PDP8L

Engineering Change Order Log

ECO SYNOPSIS FOR LOGIC OR OPTION
PDP-8L PROCESSOR LOGIC **PDP-8L**

ONLY FCO'S WRITTEN TO THE "PDP8L" OPTION ARE DOCUMENTED ON THIS FICHE.

DWG. NO.	NEW REV.	OLD REV.
D-BS-PDP8-L-2	D	C
D-BS-PDP8-L-3	B	A
D-BS-PDP8-L-4	B	A
D-BS-PDP8-L-17	B	A
D-MU-PDP8-L-18	A	Ø
A-PL-PDP8-L-18	A	Ø
K-WL-PDP8-L-19	F	E

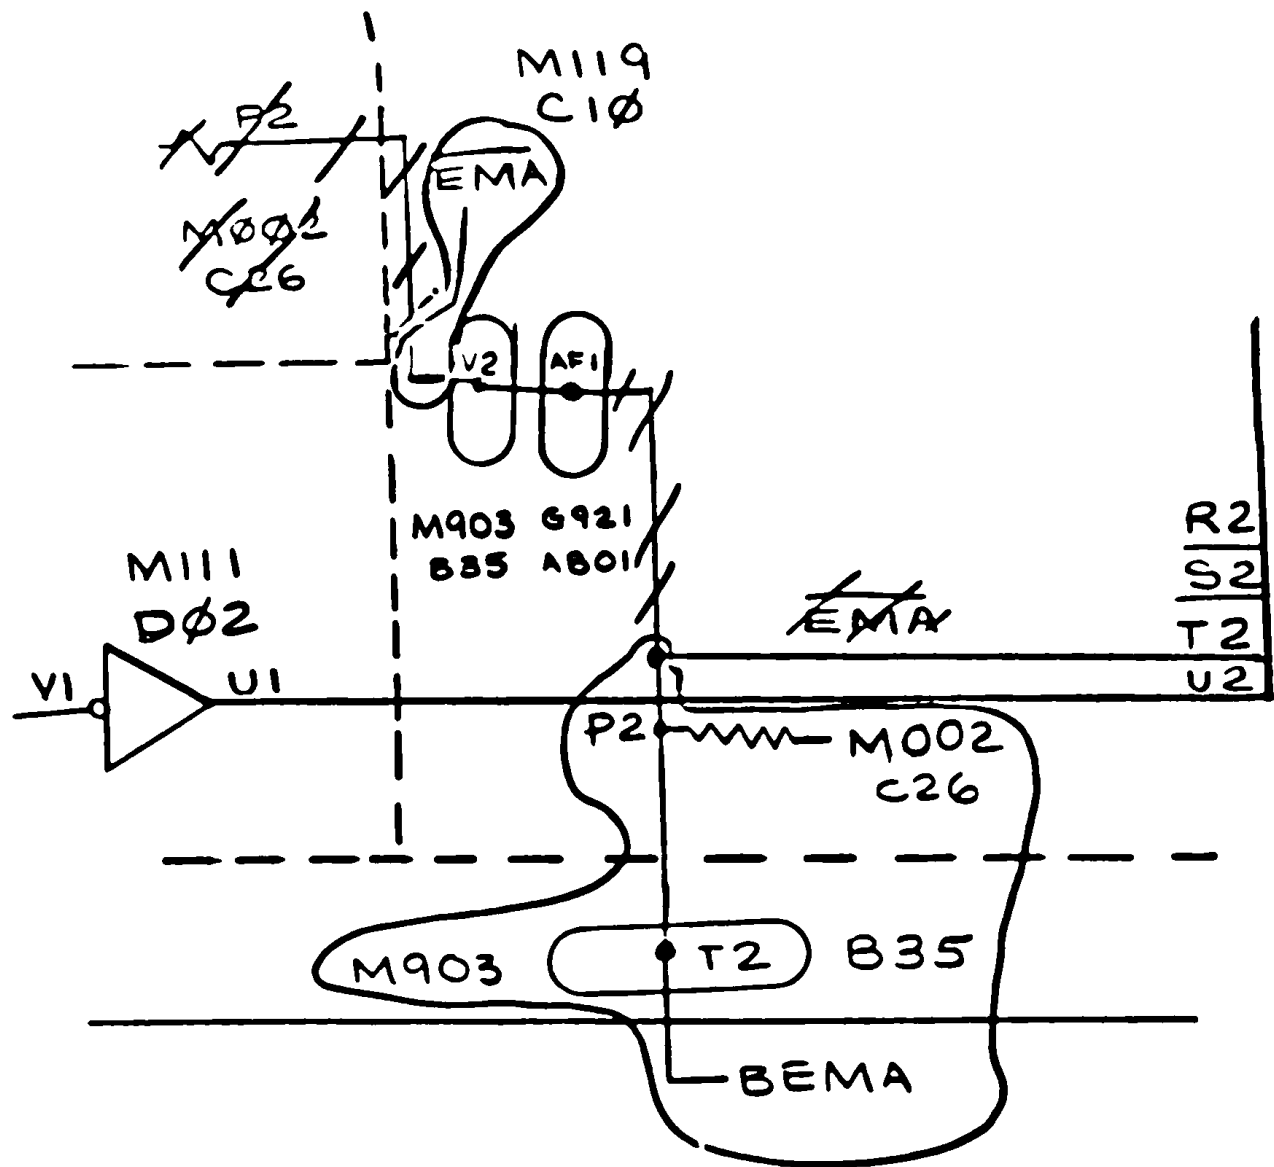
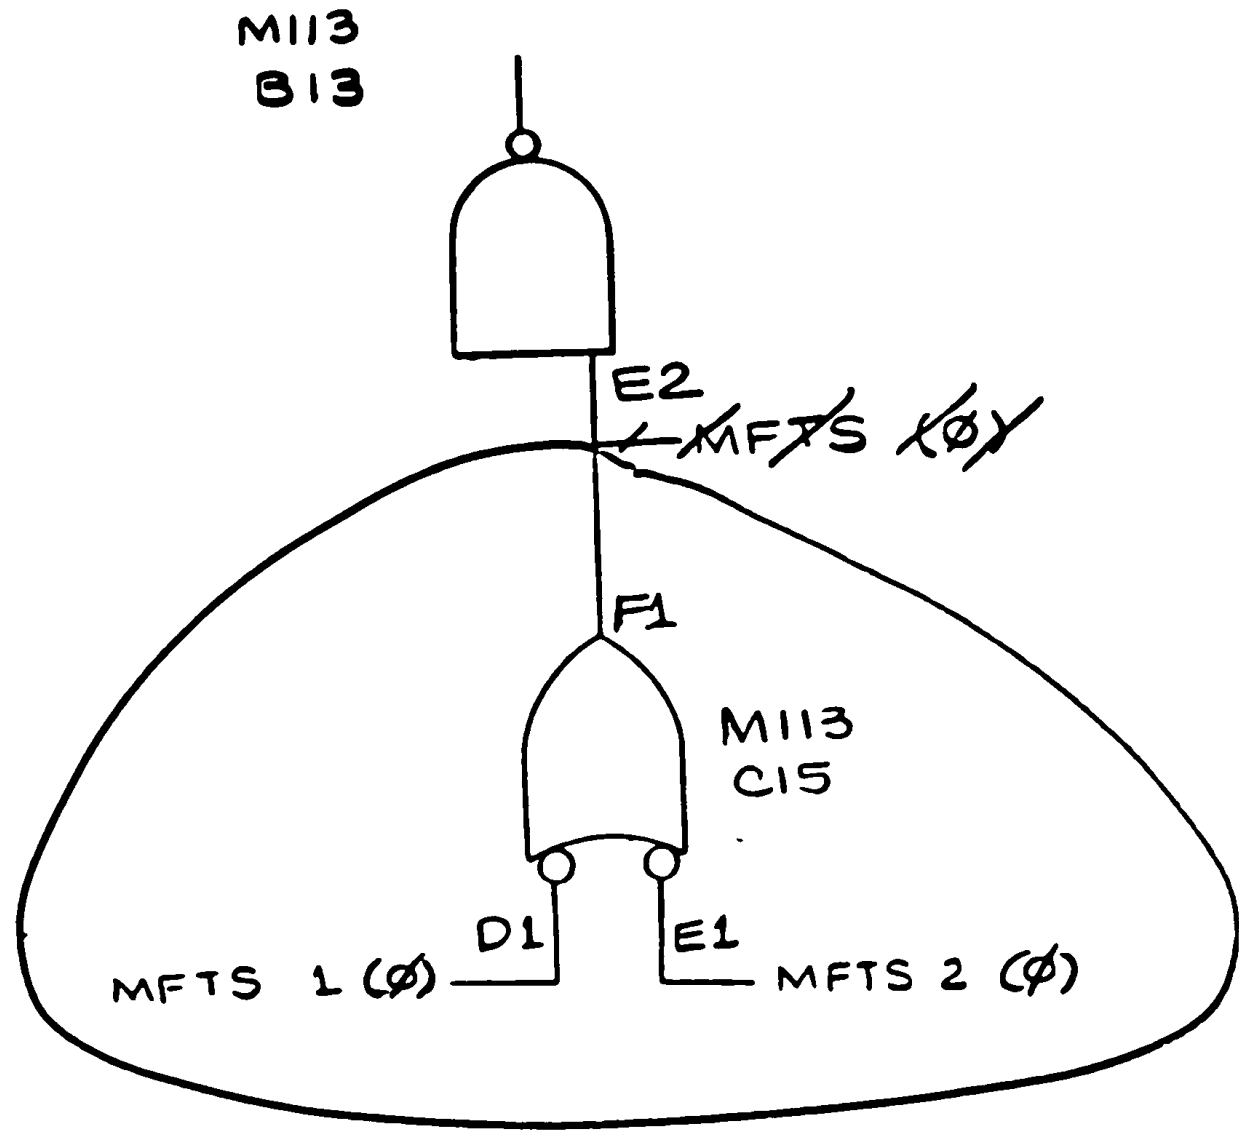
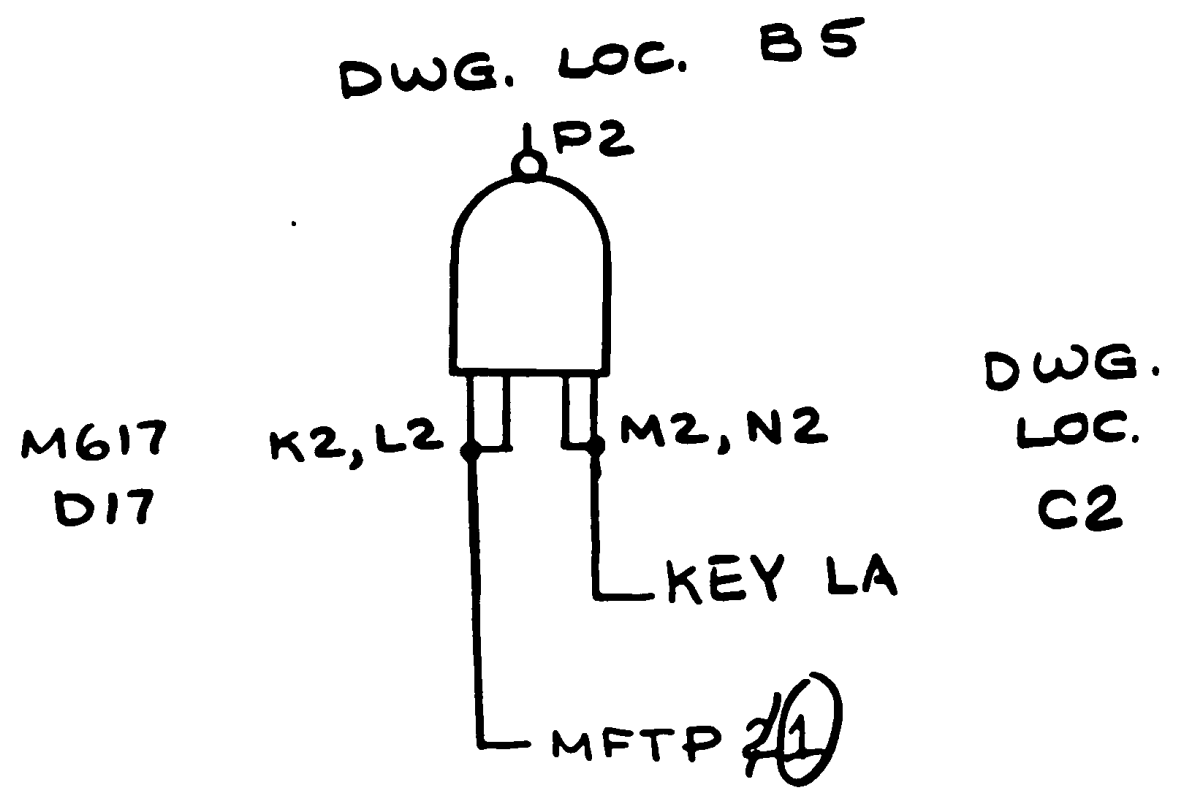
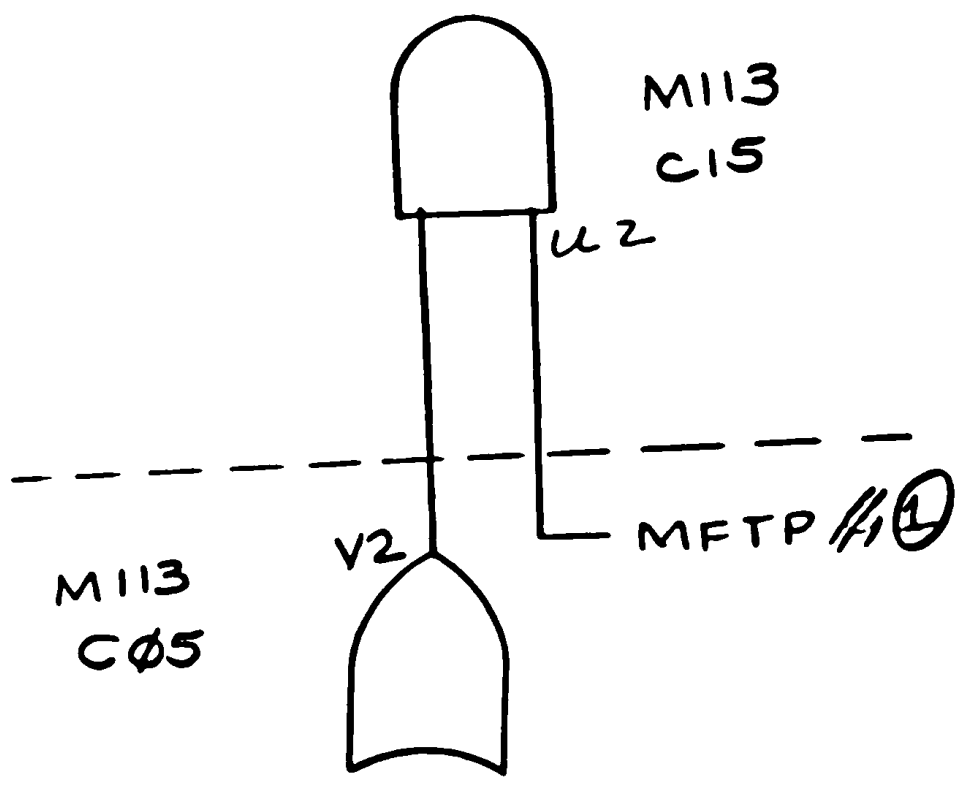
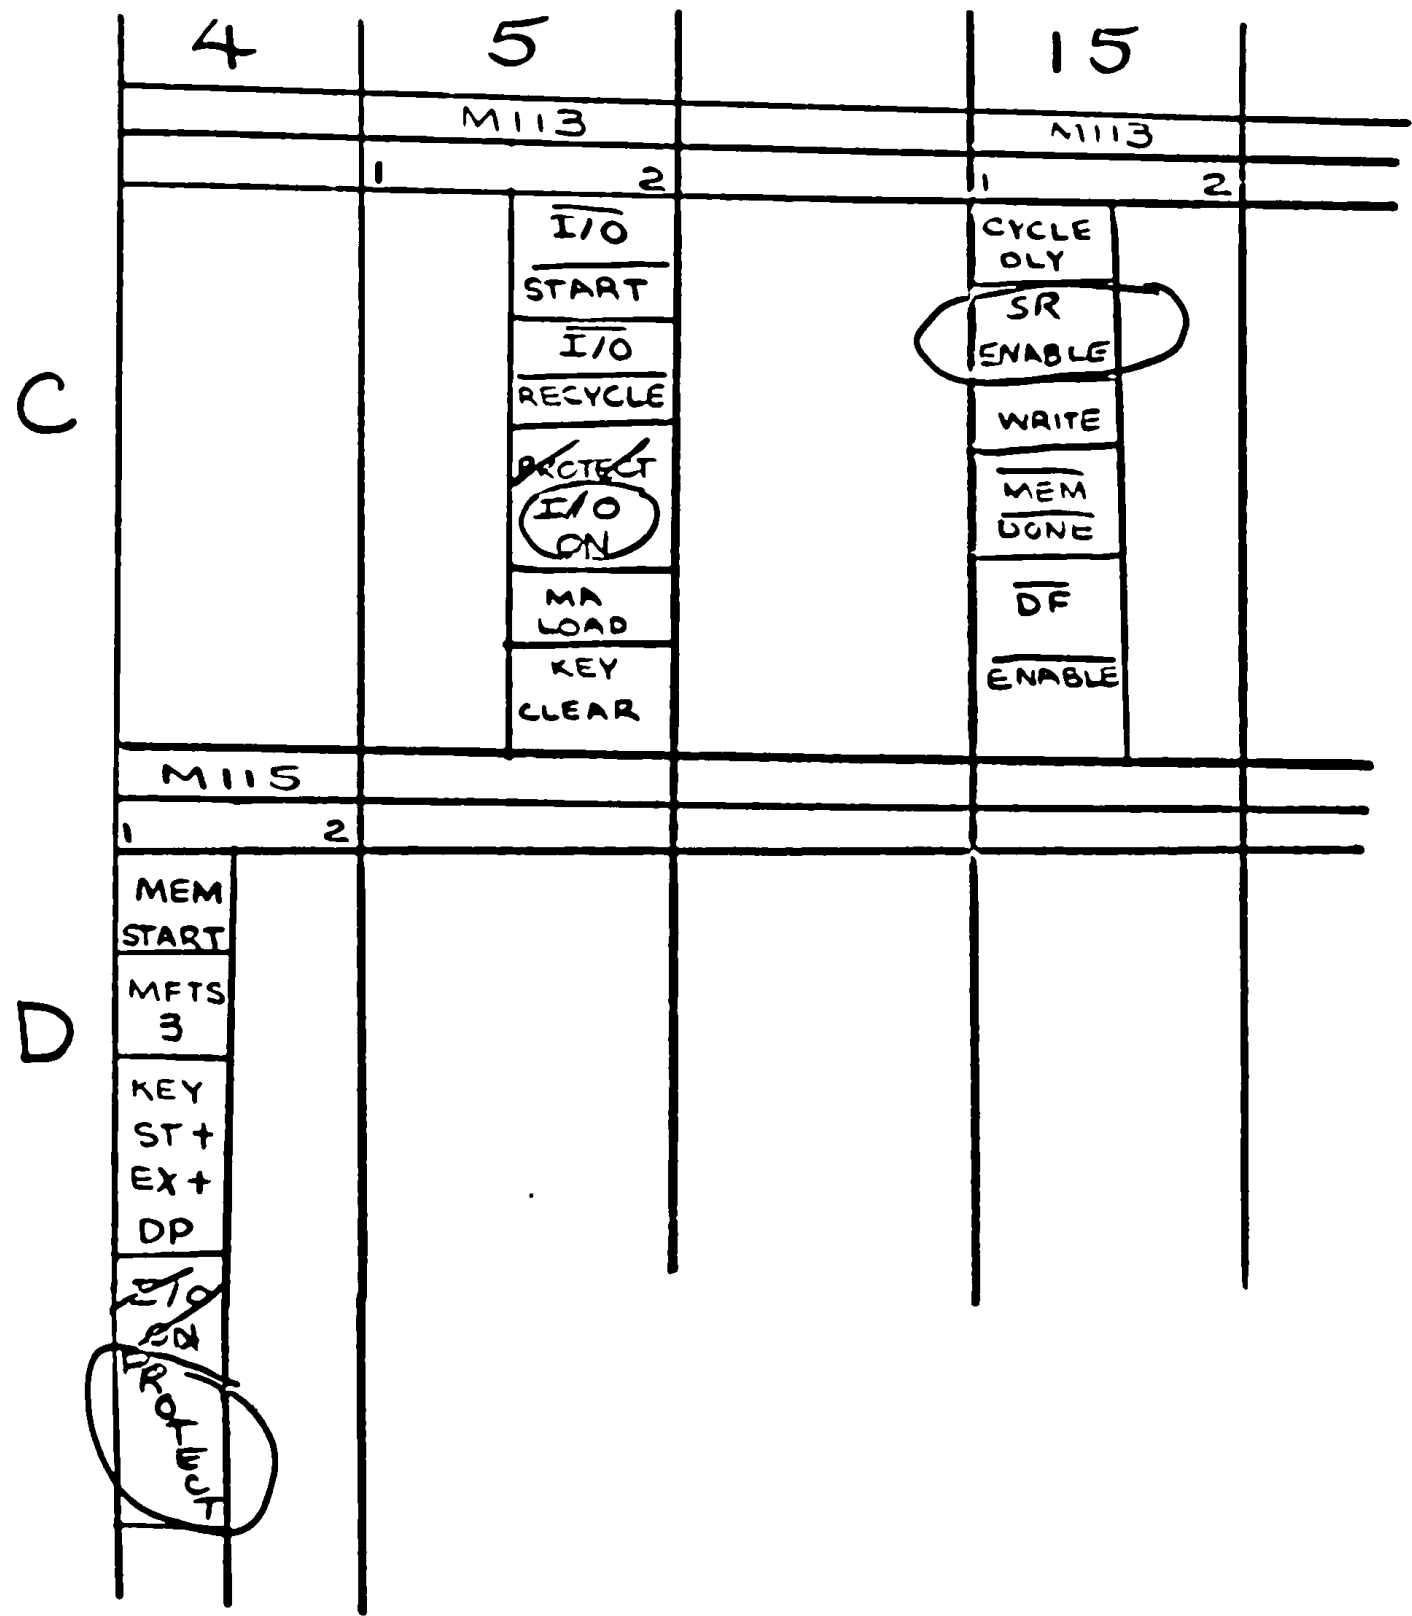
1. COULD NOT SET EA LIGHT WITH L.A. SWITCH WHEN EX. MEM. OPTION ADDED.
2. L.A. SWITCH WAS LOADING S.R.INTO M.B. & M.A.
3. COULD NOT PROTECT MEM. EX. LAST PAGE OF MEMORY WITH PROTECT SWITCH.
4. MEMORY WAS NOT PROTECTED DURING 3 CYCLE BREAK
5. WIRE LIST ERRORS.

1. CHANGED TIMING ON KEY CL. & KEY LOAD
2. ADDED GATE AT C15.
3. CHANGED EMA TO BEMA. ADDED LOGIC TO MC8L LOGIC
4. ADDED WORD COUNT 9 TO PROTECT GATE.
5. CORRECT WIRE LIST.

DCS-MPCL-0-2

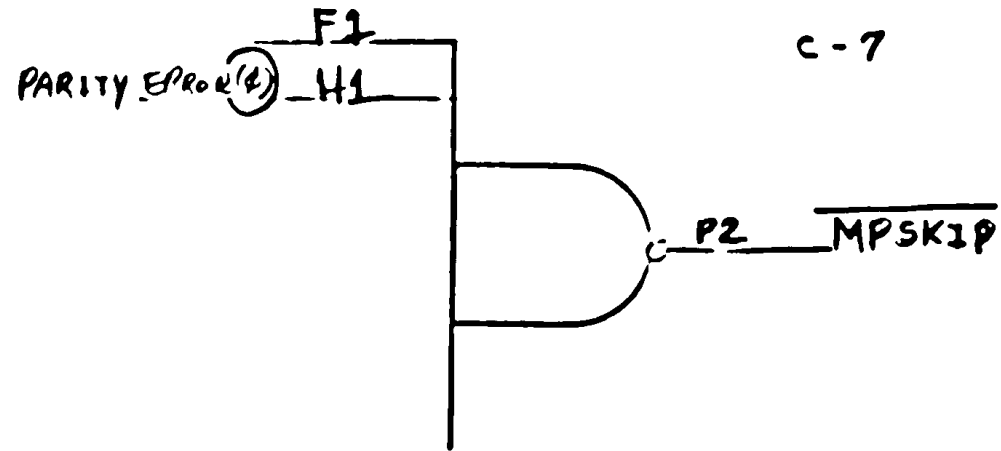
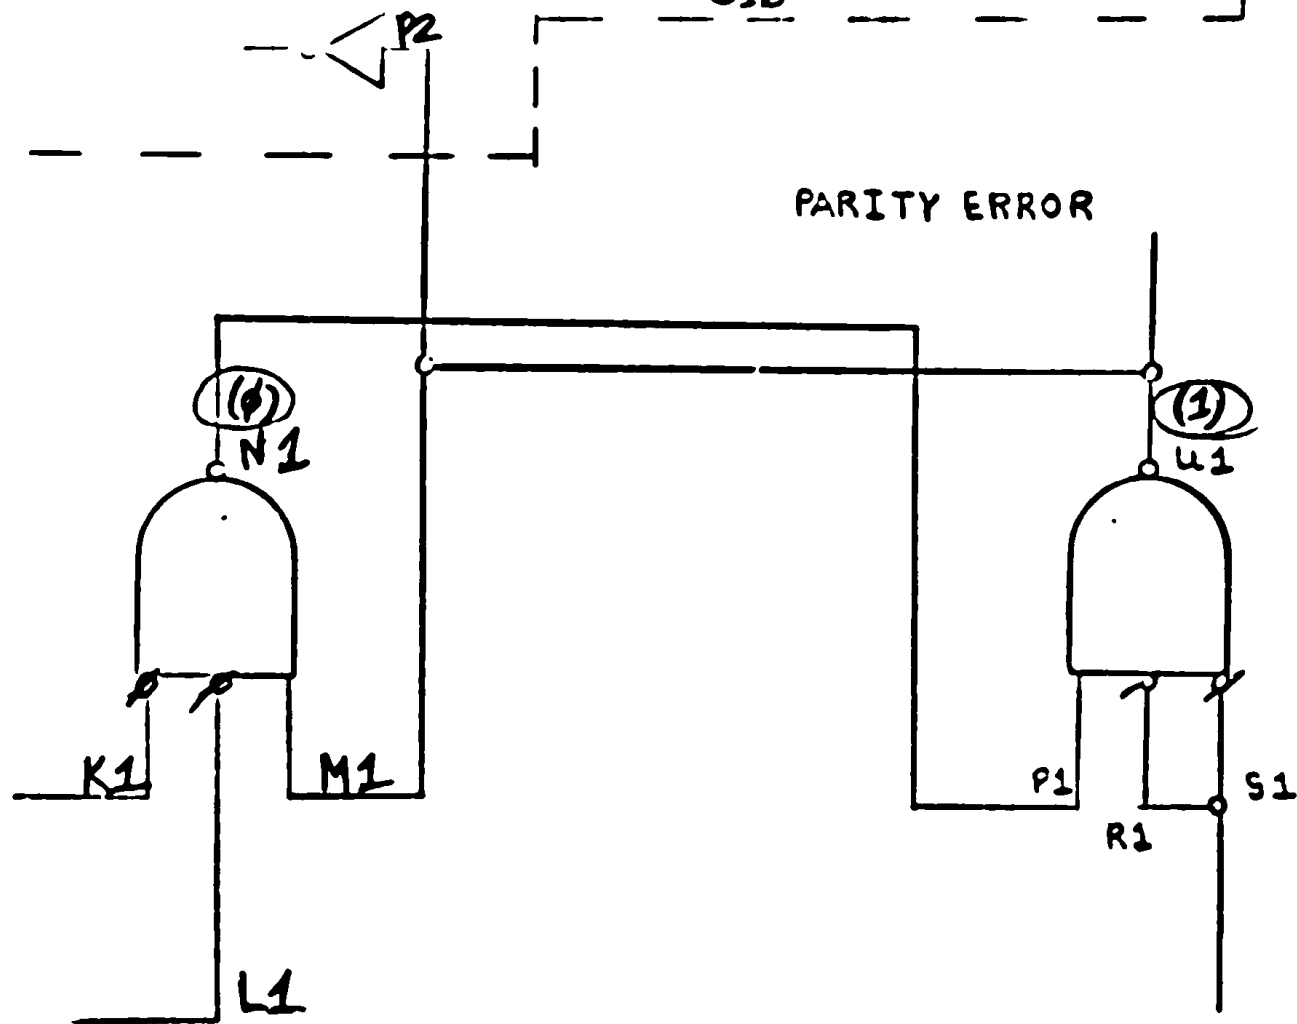
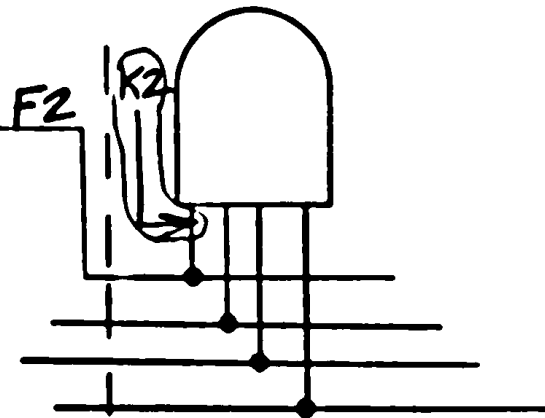
1. CORRECT WIRE LIST AND PRINTS.
2. CHANGE TO "0" SIDE OF F.F.
